**STATE OF HAWAII  
DEPARTMENT OF TRANSPORTATION  
AIRPORTS**

**ADDENDUM NO. 6  
FOR  
UST/AST REMOVALS AND REPLACEMENTS  
DANIEL K. INOUE INTERNATIONAL AIRPORT  
HONOLULU, OAHU, HAWAII  
PROJECT NO. AO1105-12**

**February 27, 2026**

**HCC AIRPORT TRAINING CENTER - SEDIMENT CONTROL SITE PLAN**

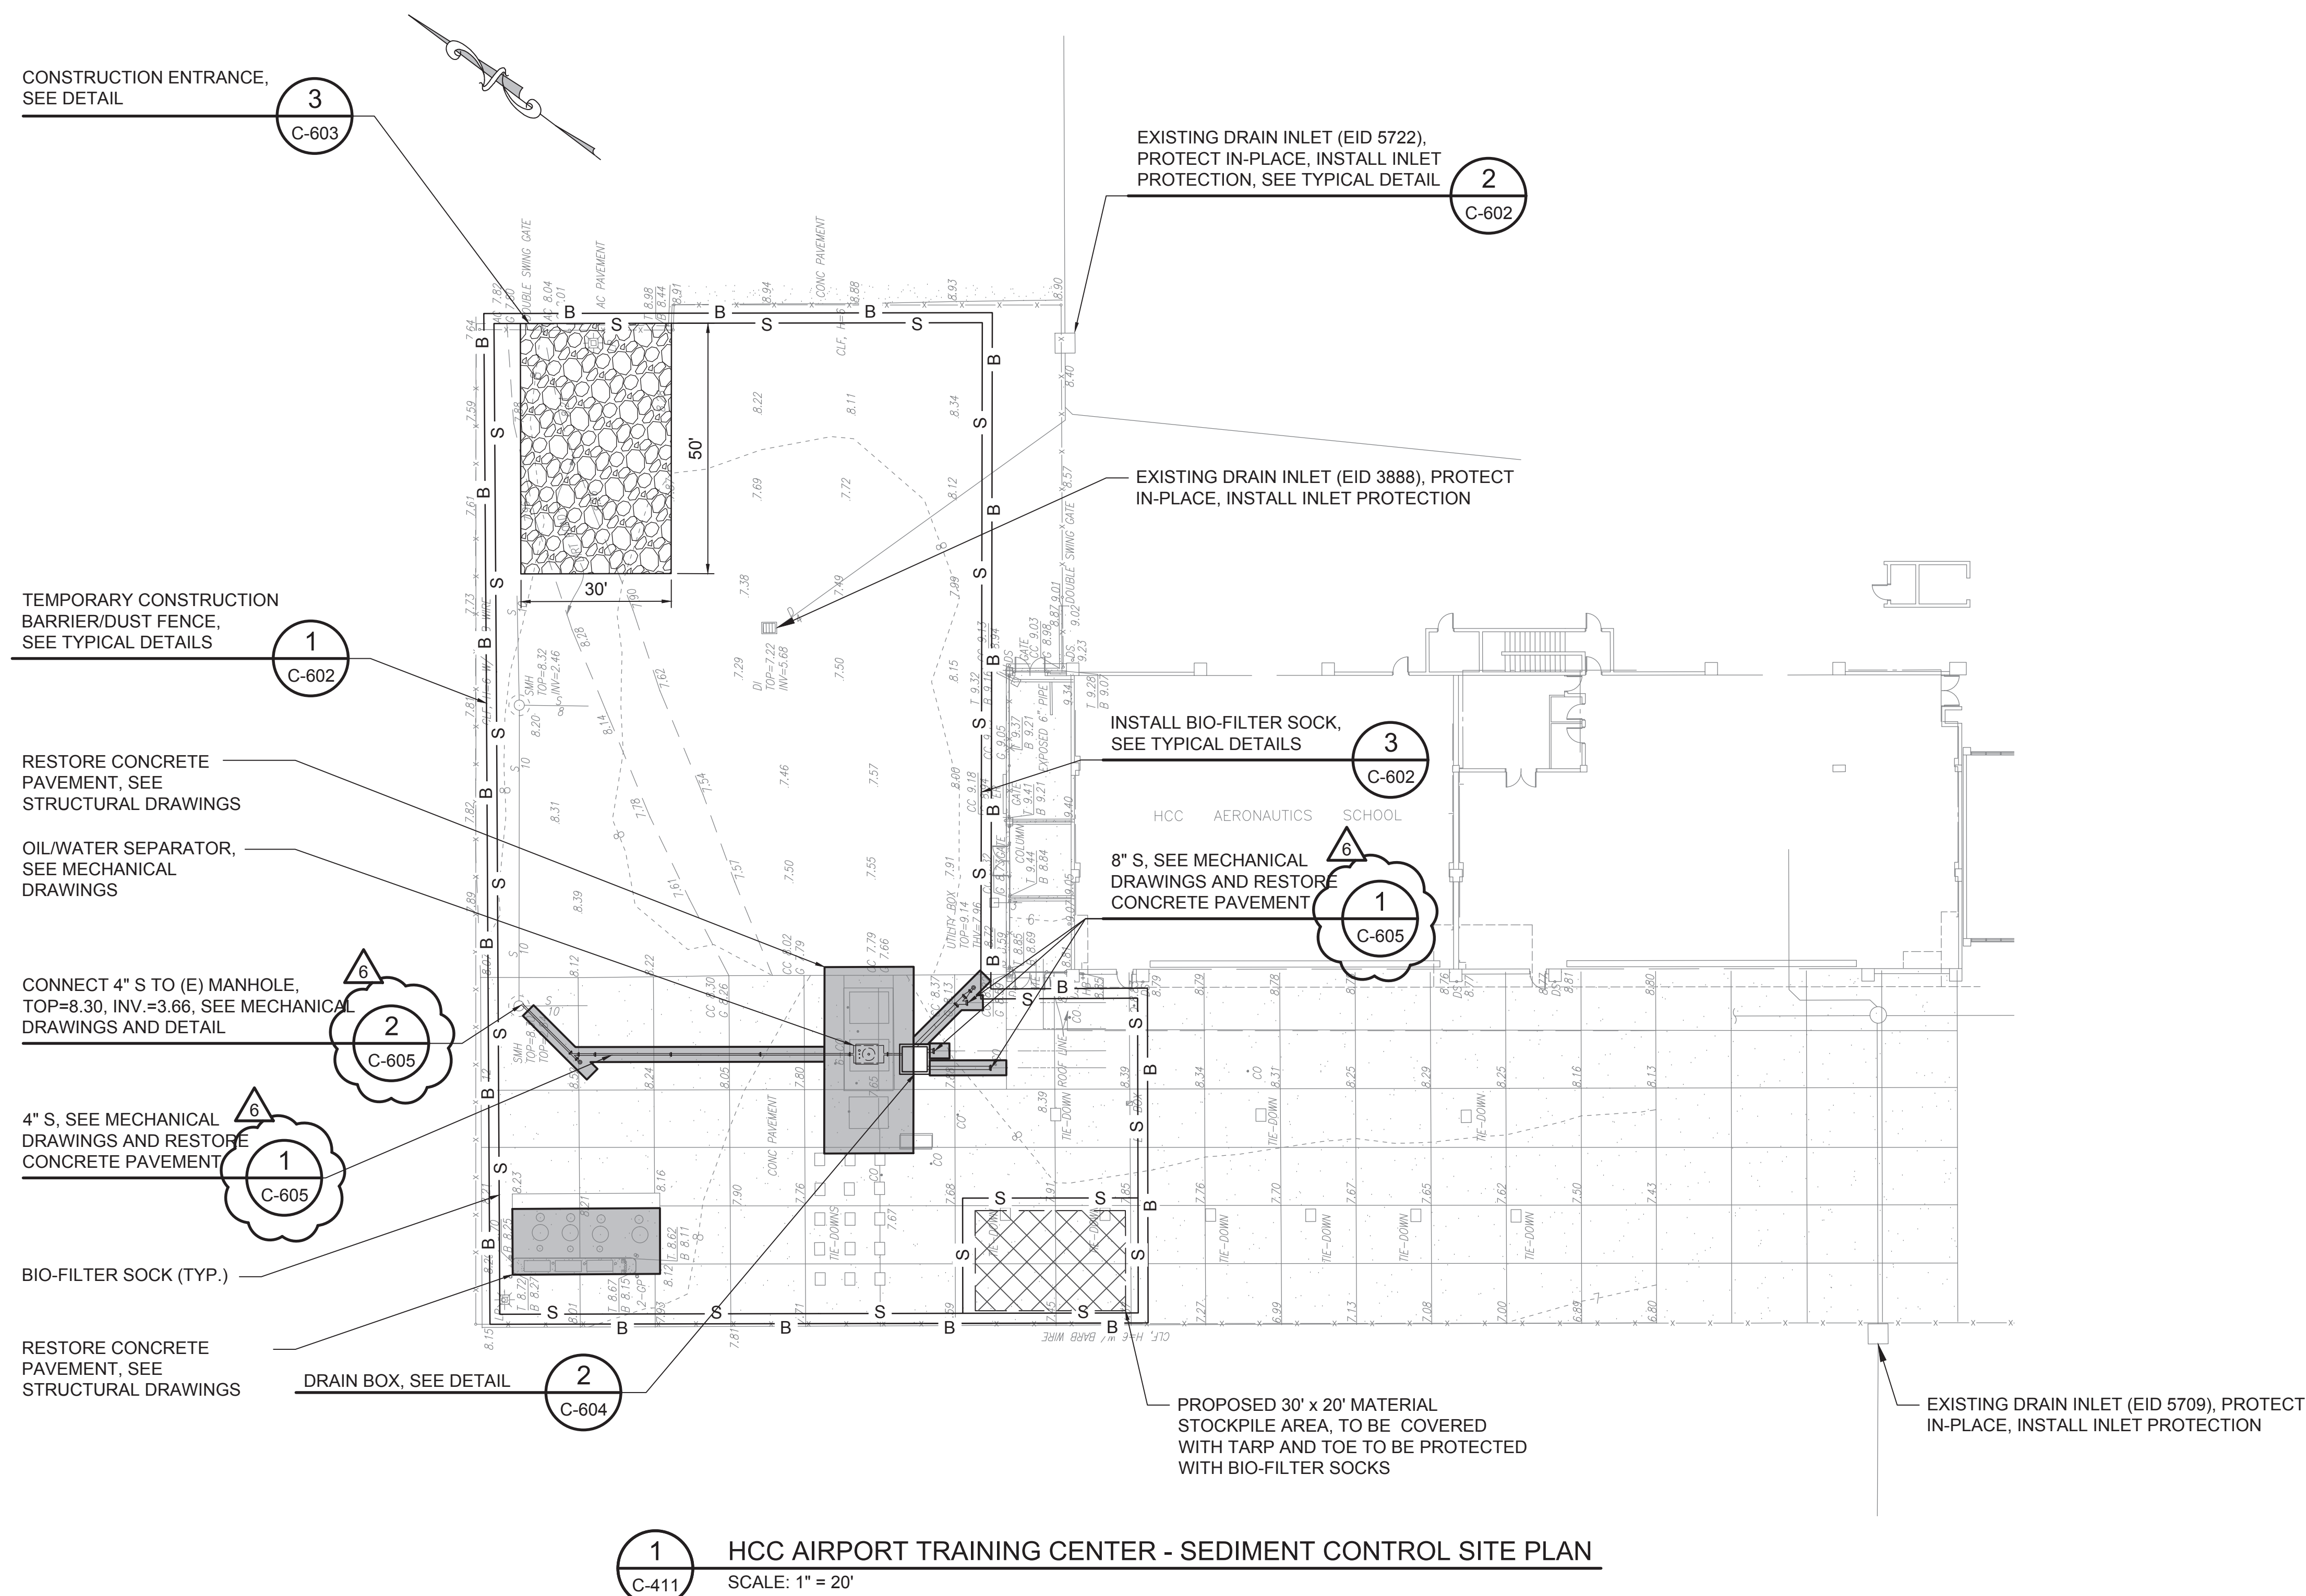
**117. HCC Airport Training Center: Sheet C-411 has callout to detail 3/C605 and detail 4/C605. On Sheet C605, there are only details 1 & 2. Please clarify.**

Callout should reference detail 1/C-605 for sewer trench and concrete pavement restoration and detail 2/C-605 for sewer pipe to manhole connection, respectively. Refer to Addendum No. 6 Drawing C-411.

**1** TEMPORARY CONSTRUCTION BARRIER/DUST FENCE DETAILS  
C-602 NOT TO SCALE

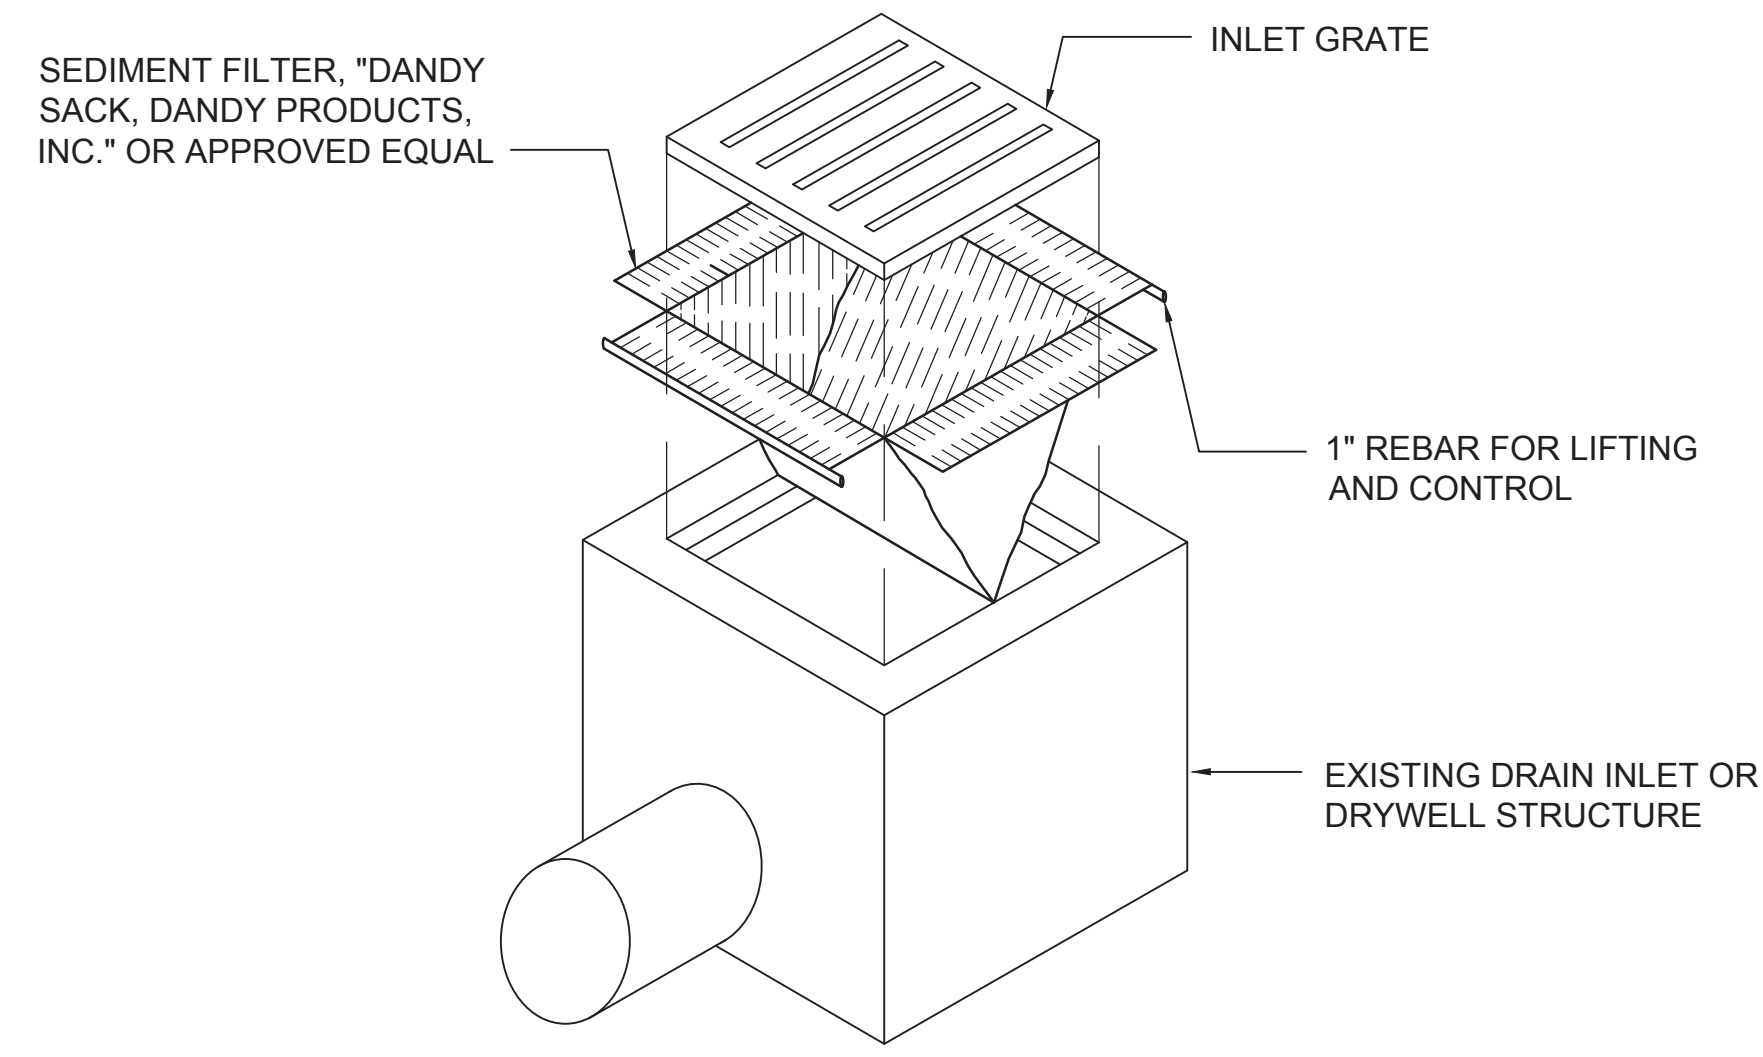
**9. per temp fence detail 1/C-602 clarify how the fence post are to be secured. it appears that they are welded to the metal plate but the section appears to show the post embedded in the concrete.**

**11. per temp fence detail 1/C-602 clarify the top and bottom of the fence. detail states both tension wire and a 1.66" pipe rail. if a pipe top and bottom rail is required will installation be done with standard fittings or will the rails have to be welded to the post? Also, there is no such thing as 6 ga ties. will standard 9 ga. ties be acceptable?**

Fence post not required to be embedded in concrete. Temporary facilities during construction shall be the responsibility of the Contractor. Refer to Addendum No. 6 Drawing C-602.

Pipe rail only and 9 ga. ties are acceptable. Temporary facilities during construction shall be the responsibility of the Contractor. Refer to Addendum No. 6 Drawing C-602.

**1 CANOPY CROSS SECTION**  
SCALE: 1/2" = 1'-0"

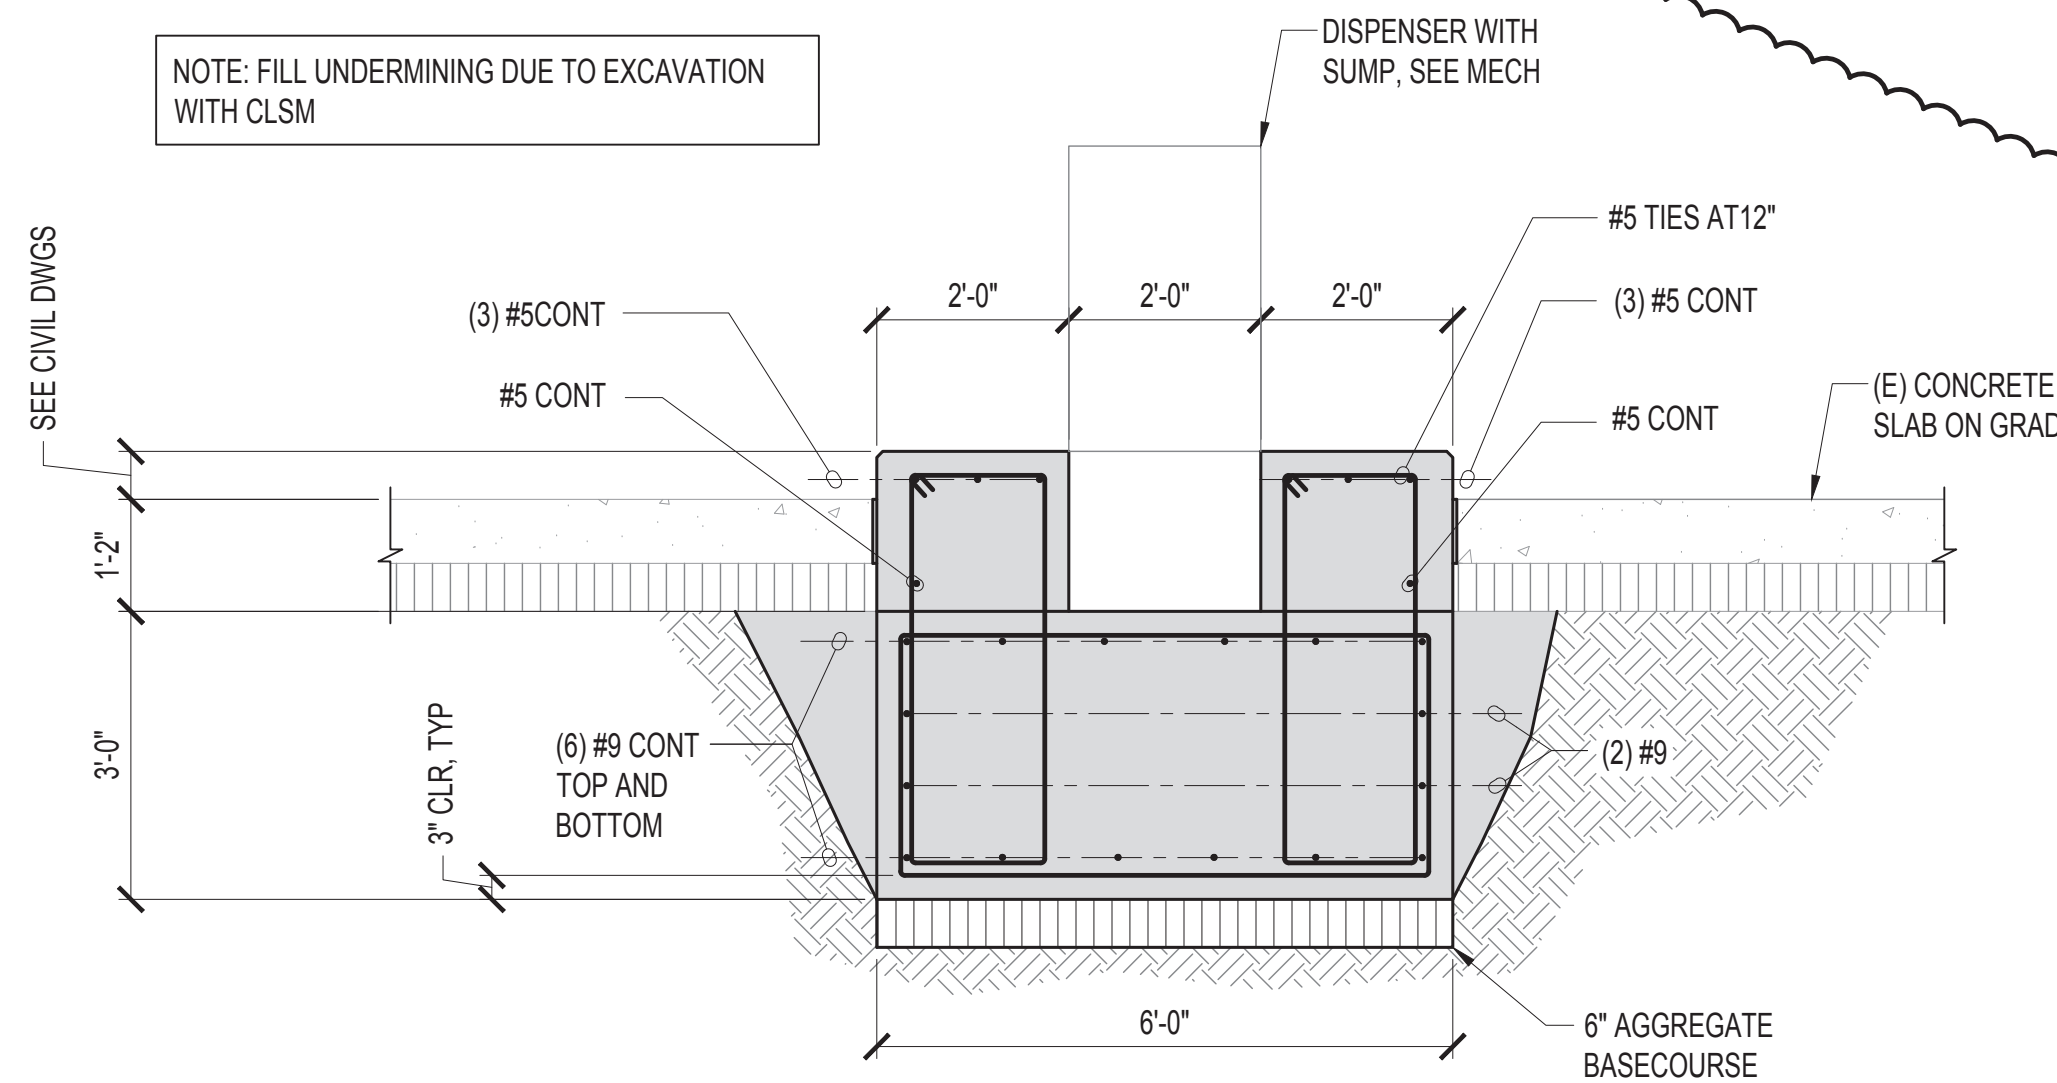
**4. Sheet S-222, Detail 1 states that the canopy design is by others and provided by the Contractor. This is not typical and will create situation where the State may not get the benefit of a quality canopy with the desired design by the State. Potentially, the lowest bidder may not have the best design, or value and the State will not find out about this until after the project is awarded. I suggest that the State hire a reputable canopy manufacturer/installer to provide the design. This creates a level "playing field" for the Bidders. The canopy cost and installation can be a cost that is provided directly to the State and added as an Allowance to the bid proposal document.**

A) No, the W6x15 steel beam is not required. The steel beam was provided for high hose retractors. Plans were revised to provide the fuel dispensers with high hose retrievers on support bar assemblies mounted to the fuel island. Refer to Addendum No. 6 Drawings S-222, M-001, and M-231.

**LEI STAND - DAY TANK FUEL PIPING DIAGRAM**

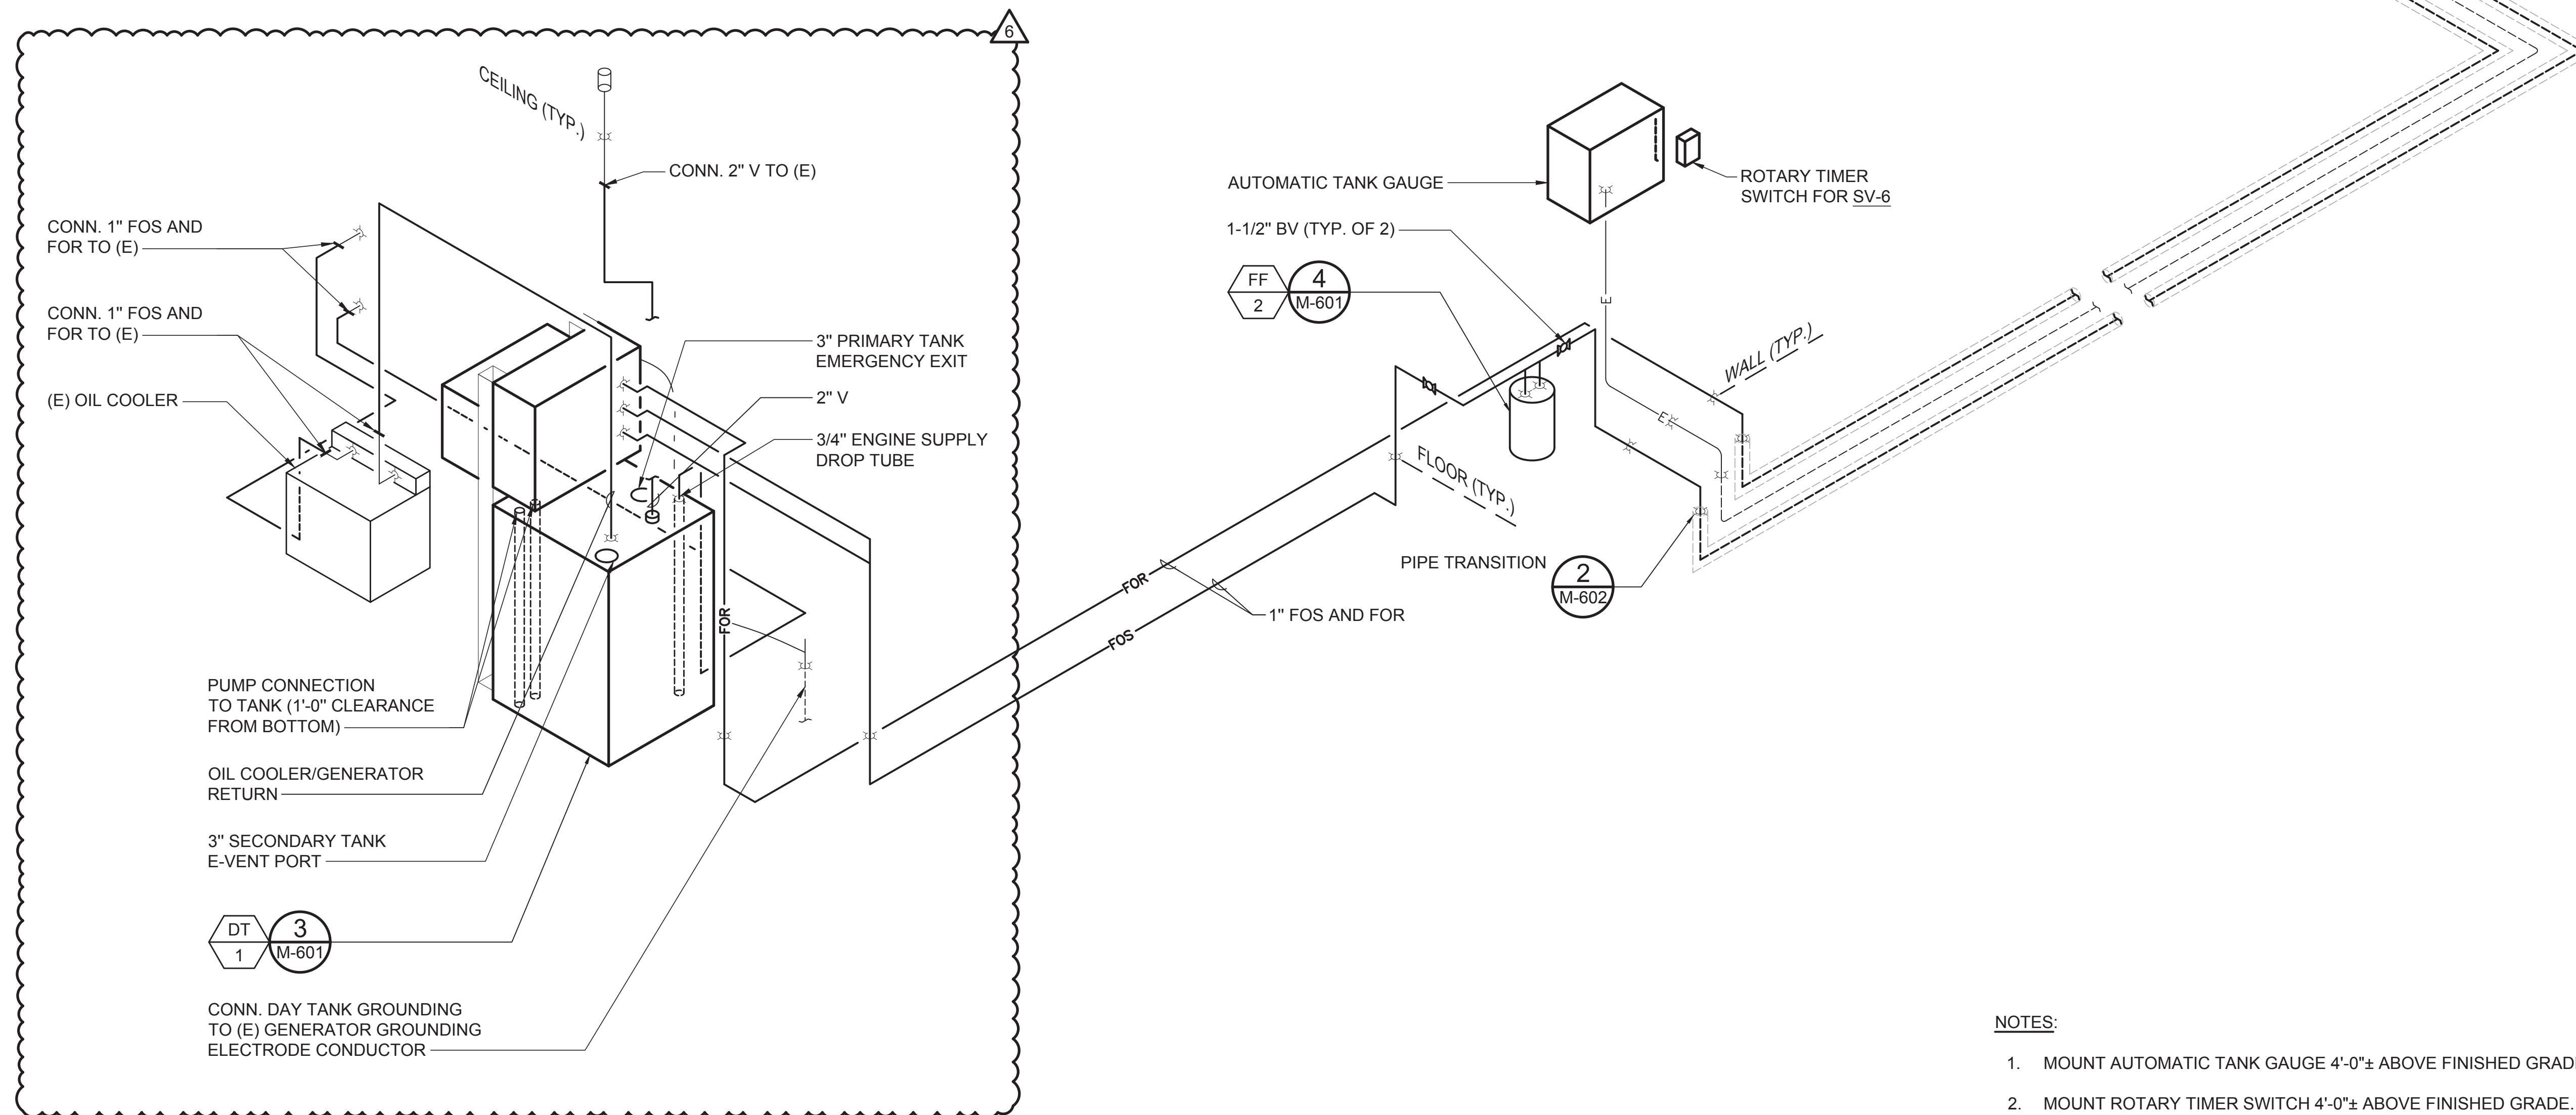
**39. In reference to Lei Stand, drawings M-332 and M-601 Detail 2, there is a ground rod with inspection well shown in the building, can this be located outside of the building so is not to have to break existing concrete floor to install ground rod and inspection well?**

Intent is to connect the day tank to the existing grounding rod as indicated on Detail 1/M-321, "CONN. DAY TANK GROUNDING TO (E) GENERATOR GROUNDING ELECTRODE CONDUCTOR". Detail reference for new grounding rod, wire, and inspection well to be removed from 1/M-332. Refer to Addendum No. 6 Drawing M-332.
